M4 Junctions 3 to 12 Smart Motorway

Non-Material Change

Sipson Road Subway

Technical Note

Figure 7 Extract of Engineering Design Sipson Road Subway North Widening Version C01 A, Issued for Construction Sipson Subway in GA drawing HA514451-CHHJ-HGN-SZ_MLZZZZZZ_Z-DR-CH-1088, 18/02/22

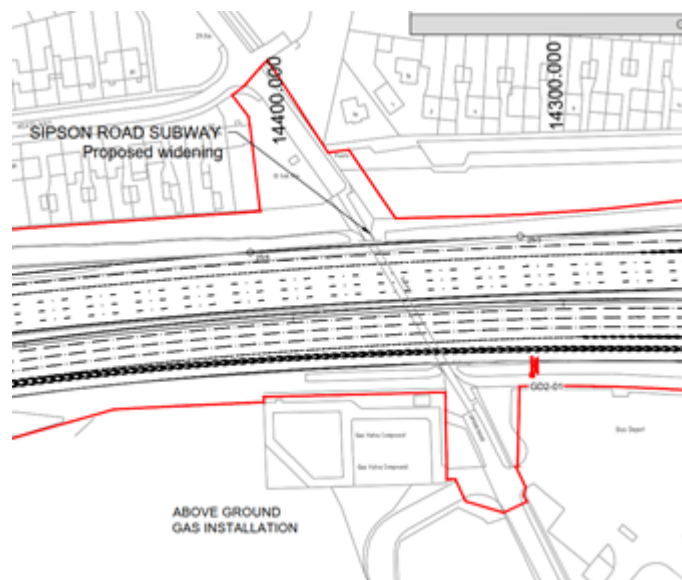
The design change as a result of the 2021 NMC Design is restricted to the construction of a 1.2m wide retaining beam (supported on pile caps and piles) to the northern side (eastbound) of the M4 which has no impact on vegetation clearance or re-planting proposals. The only difference is the appearance of the beam on top of the subway entrance (refer to Figure 2 and 3 in Chapter 4).

Figure 7 illustrates the limit of the engineering works.
